Intel[®] 82371EB (PIIX4E)

Specification Update

April 1999

Order Number: **290635-007**

4. USB Bandwidth Reclamation Errata

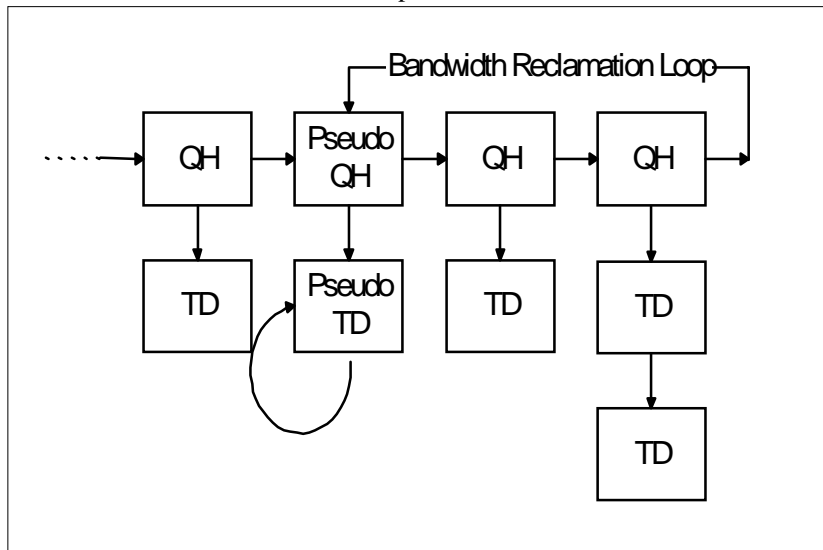
Problem: This errata affects data transfers in conjunction with a UHCI driver utilizing bandwidth reclamation. In a data structure which implements bandwidth reclamation, when all the queue heads have their terminate bit set (empty QH's), the USB subsystem will be unable to read a new frame pointer and will continuously loop through the bandwidth reclamation queue heads. The effect of the errata is that the USB subsystem will continue to send out Start Of Frame packets but transfer no data. On the PCI bus the PIIX4 will continuously read the queue heads within the bandwidth reclamation loop. For additional information on PIIX4 host controller operation refer to the Universal Host Controller Interface (UHCI) Design Guide (order number 297650).

Workaround: When using bandwidth reclamation, the UHCI driver should insert a pseudo queue head with a pseudo transfer descriptor within the bandwidth reclamation loop. The PIIX4 will fetch this queue head and transfer descriptor on every frame, but will not transfer any data and will never be terminated. The following bits must be properly set to implement the workaround:

QUEUE HEAD LINK POINTER (DWORD 0: 00-03h)

The Queue Head Link Pointer (QHLP=bits [31:4]) must be set to point to the pseudo TD.

The QH/TD Select (Q=bit 1) must be set to 1 indicating it is a QH.

The Terminate bit (T=bit 0) must be set to 0 indicating that the link pointer field points to a valid TD.
